2020 Corvette: Recall Notice: #N202309350: Non-Compliance - Interior Trunk Release Button Inoperative Ten Minutes After Power Off

Subject: N202309350 — Interior
Trunk Release Button
Inoperative Ten Minutes
After Power Off

Models: 2020 Chevrolet Corvette

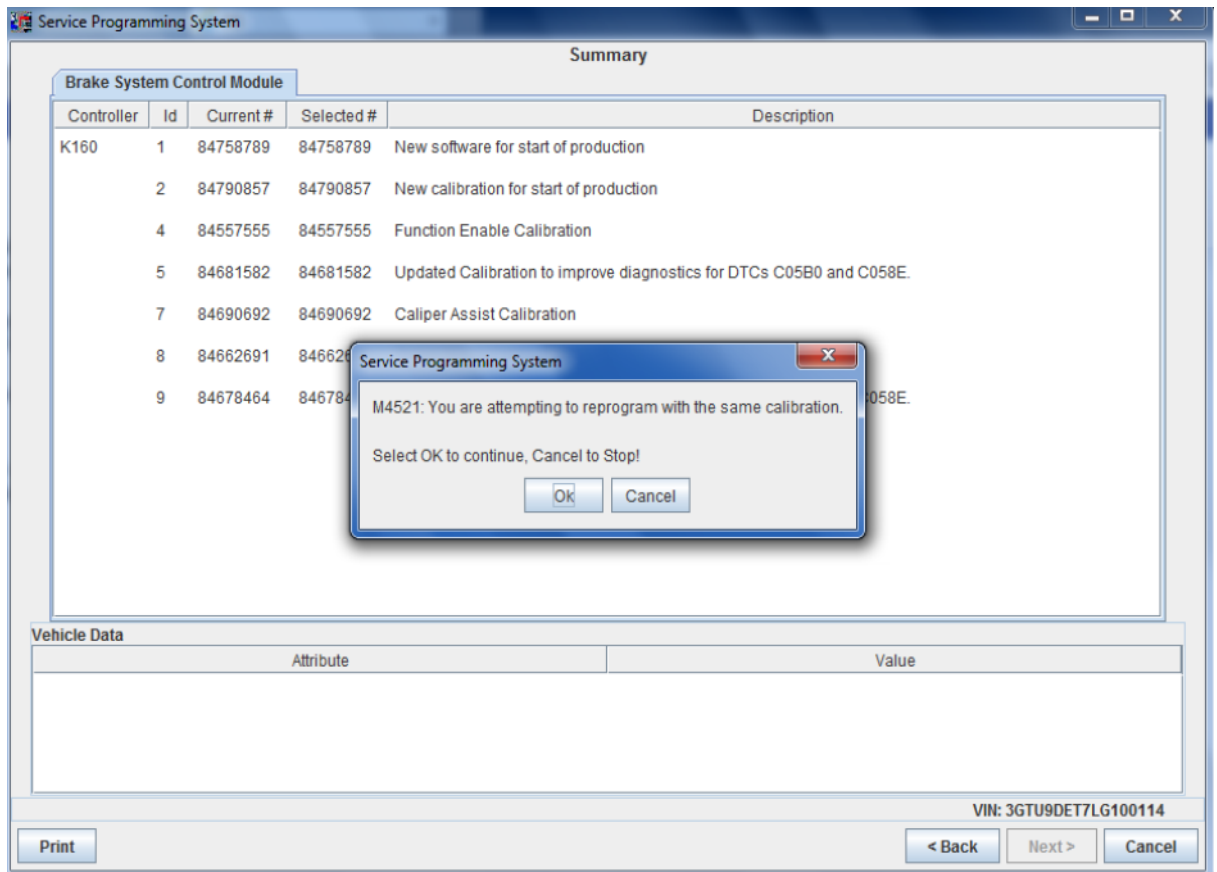
Important: *To avoid warranty transaction rejections, carefully read and follow the instructions below:

- The SPS Warranty Claim Code must be accurately entered in the "SPS Warranty Claim Code" field of the transaction.
- When more than one Warranty Claim Code is generated for a programming event, it is required to document all Warranty Claim Codes in the "Correction" field on the job card. Dealers must also enter one of the codes in the "SPS Warranty Claim Code" field of the transaction, otherwise the transaction will reject. It is best practice to enter the FINAL code provided by SPS.

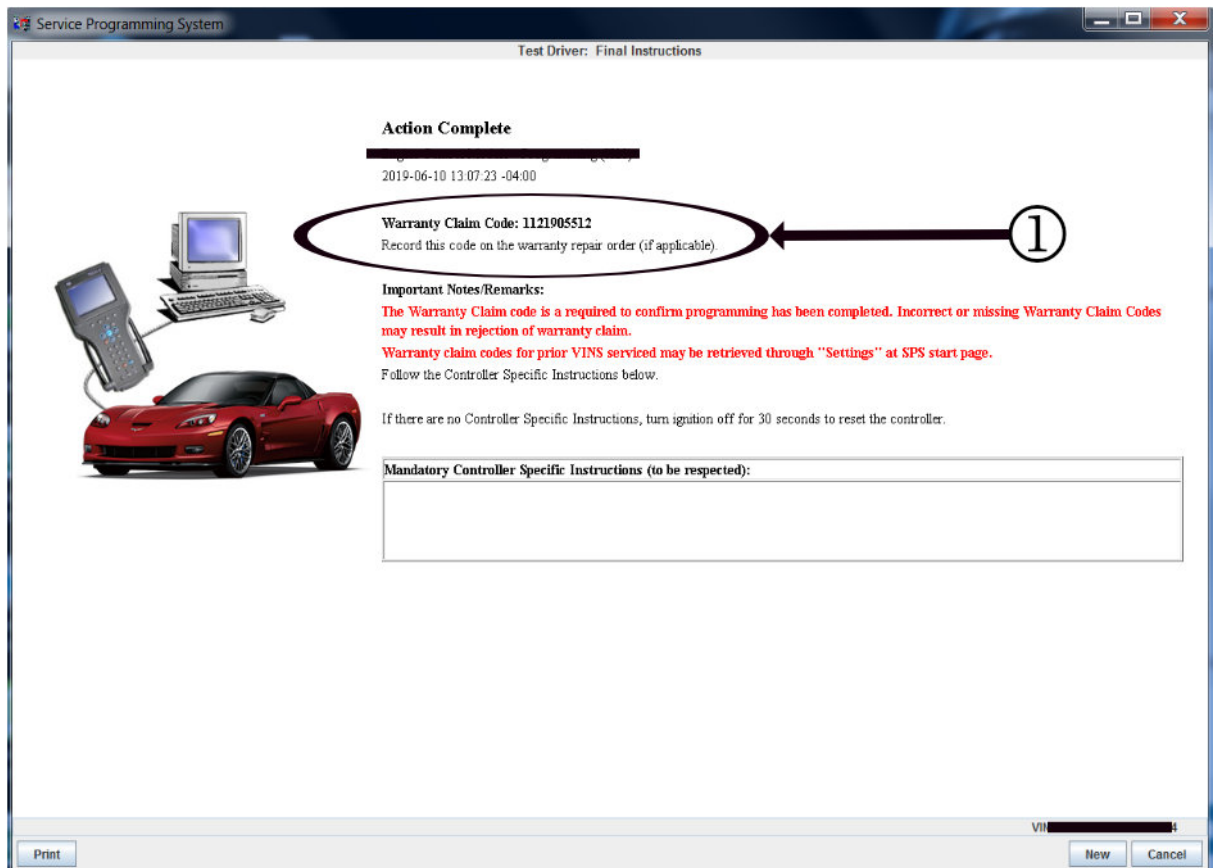
Important: If the Same Calibration/Software Warning is noted on the SPS Summary screen, record the warranty claim code (WCC) and select OK and follow screen instructions. After a successful programming event, the WCC is located in the Service Programming System dialogue box of the SPS Summary screen. No further action is required. Refer to the Warranty section of the bulletin.

1. Reprogram the body control module. Refer to *K9 Body Control Module: Programming and Setup* in SI.
